# Glen Earrach Energy Pumped Storage Hydro Development

Additional Information

Glen Earrach Energy Ltd

Figure 2-1: Baseline Flow Duration Curves

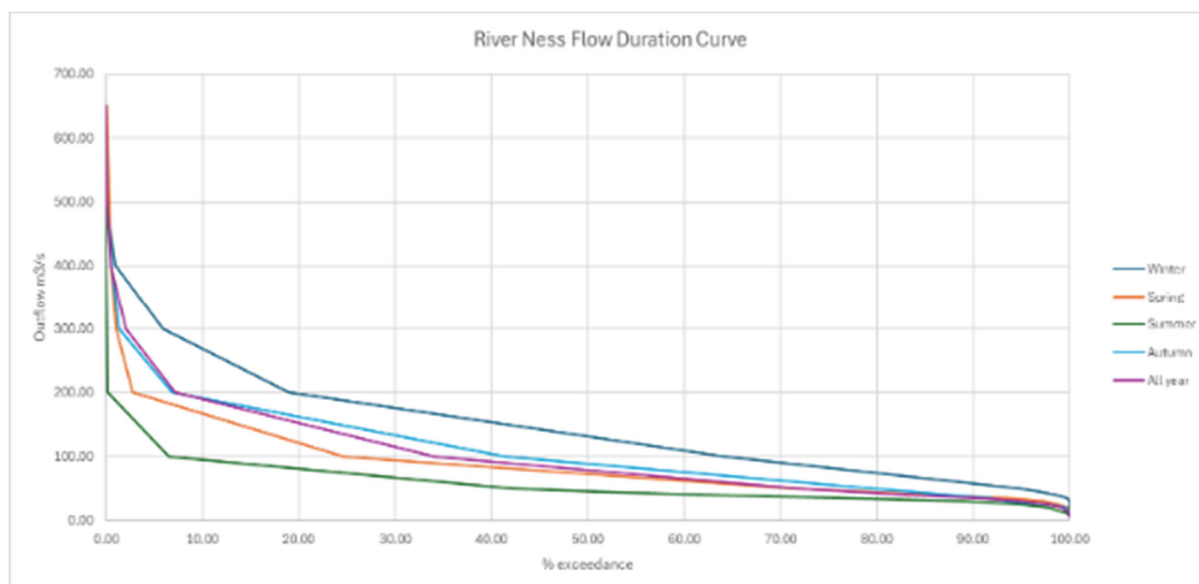
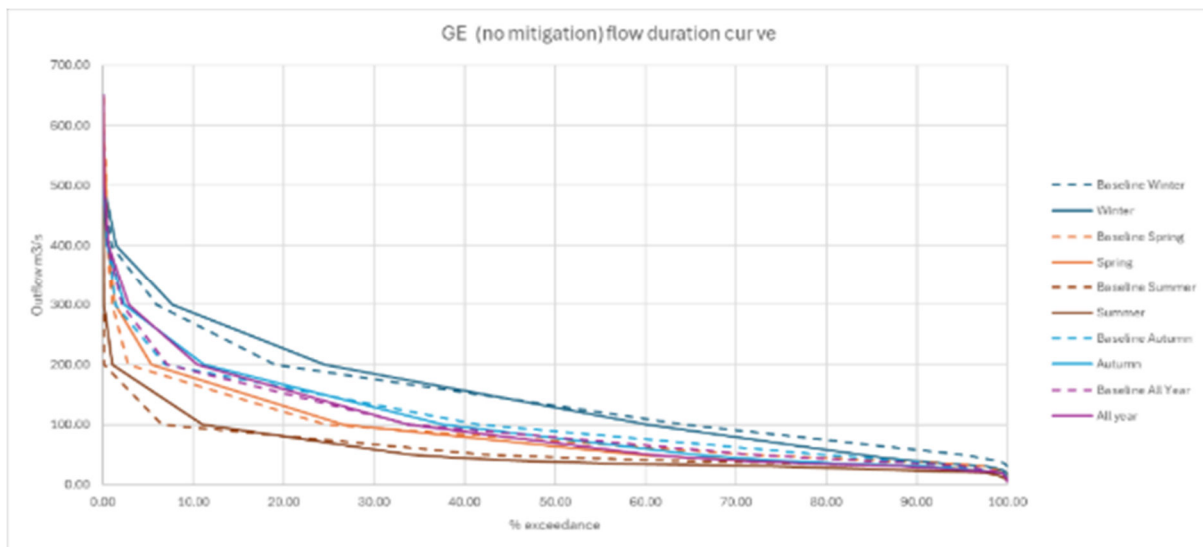
- 2.5.2.1 **In section 5, a number of modelled annual and seasonal flow and level duration curves for a range of scenarios are presented. These are used in assessing the potential impacts of any prolonged low flows/levels at the weir and in the River Ness. However, they are small, busy graphs and it's not possible to pick out the degree of changes with any precision, particularly at low to moderate levels. Could this data be presented in a different format.**

- 2.5.2.2 **Could this data be provided in tables that show the baseline, baseline plus Glen Earrach and baseline plus all PSHs?**
- 2.5.2.3 **Response:** In addition to the flow duration curves provided in Appendix 11.1 of the EIAR, the supporting numerical data underlying these curves are presented below.

The annual and seasonal flow duration curves for the River Ness based on baseline scenario are summarised in Figure 2.1.

**Figure 2-2 The Proposed Development with no mitigation Flow Duration Curve****Table 2-2 Loch Ness levels – The Proposed Development with no mitigation**

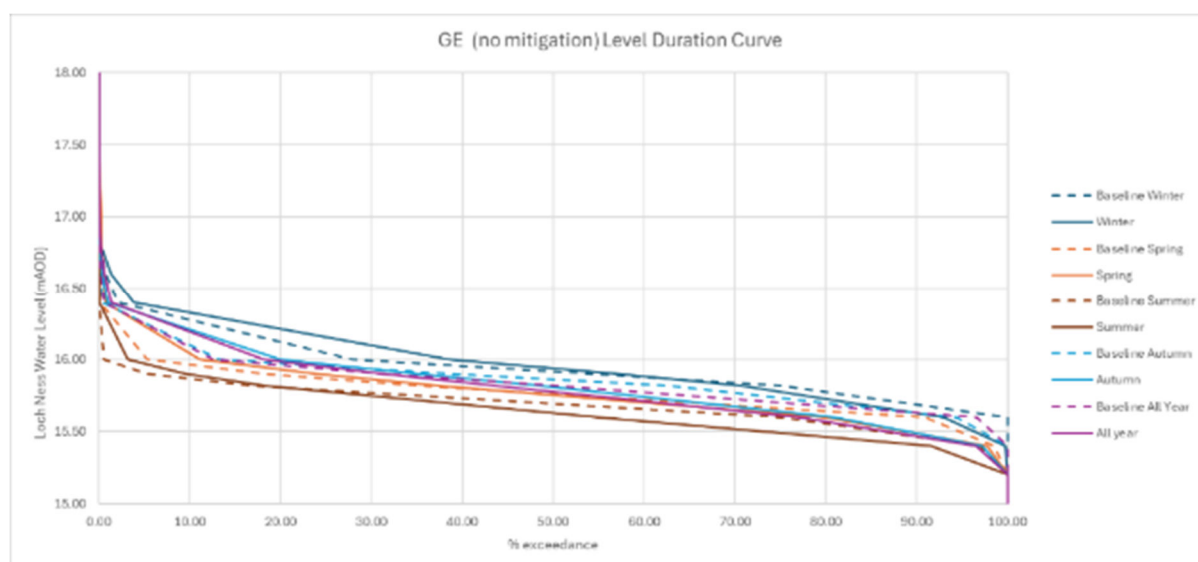
**2.5.4.1** We assume that reach-specific ecological flow thresholds are not known for river levels in the Ness. Therefore a table showing the flow duration curve data presented in inserts 13, 15 and 17 from Appendix 11.1 would allow us to better see the changes in flow. We suggest the tables show the 99, 95, 90, 80, 70, 50 and 30th flow exceedance percentiles.

**2.5.4.3** In respect of the Proposed Development-only scenario, the data contained in Insert 13 of the EIAR are presented in Table 2-1 and Figure 2-2 of this Additional Information.
